HISTORIC AND DESIGN REVIEW COMMISSION

April 05, 2017

HDRC CASE NO: 2017-133
ADDRESS: 222 WICKES
LEGAL DESCRIPTION: NCB 942 BLK 1 LOT W 67.3 FT OF 6 AT 222 WICKES
ZONING: RM-4,HS
CITY COUNCIL DIST.: 1
DISTRICT: King William Historic District
LANDMARK: Rutledge / Ingram House
APPLICANT: Delia Bora
OWNER: Delia Bora
TYPE OF WORK: Replacement of four front windows, front door installation
REQUEST:

ENCLOSED WINDOW OPENING

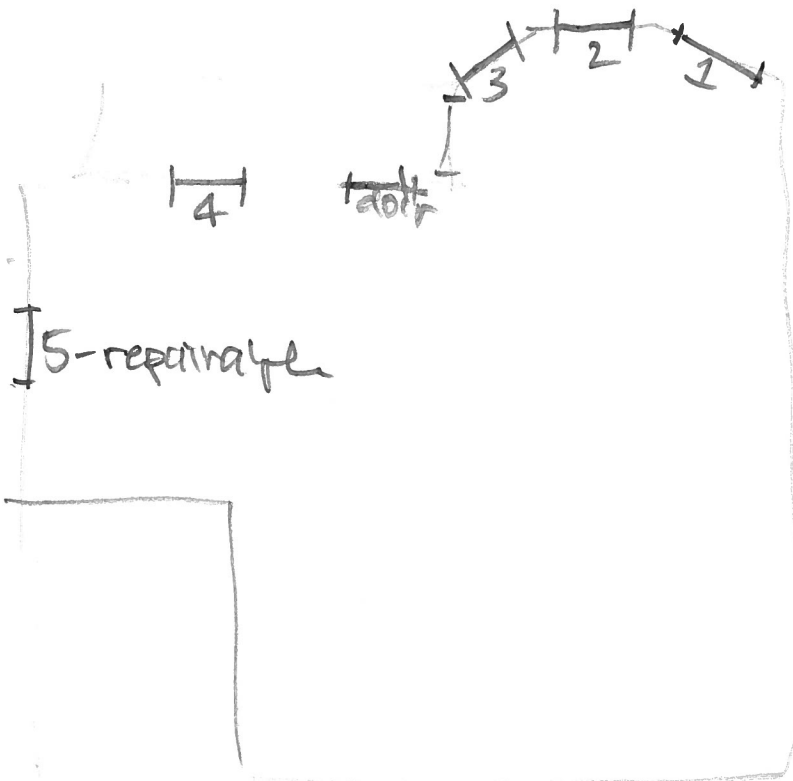
- d. PORCH OPENING – Many Folk Victorian houses in San Antonio feature a vernacular design element that includes two front porch door openings, one facing the side yard and the other facing the street. Per a March 2016, photo, a window was located in the side porch opening, which was probably an original door opening. At this time, this opening has been enclosed. The Guidelines for Exterior Maintenance 6.A.i., notes that historic window and door opening should be enclosed. Additionally, the sizes of original window and door openings should be preserved. Staff finds that the existing opening should be restored to a window opening that match those that are on the front facing window bay.
- e. FRONT DOOR – A new front has been installed. Staff finds the new front door to be architecturally appropriate for the historic structure. The door should be painted to match the colors of the house.

Staff does not recommend approval of item #2 based on finding c. Staff recommends that the opening be restored to its previous size and a window be installed that matches the 4 front window in regards to size, material and profile.
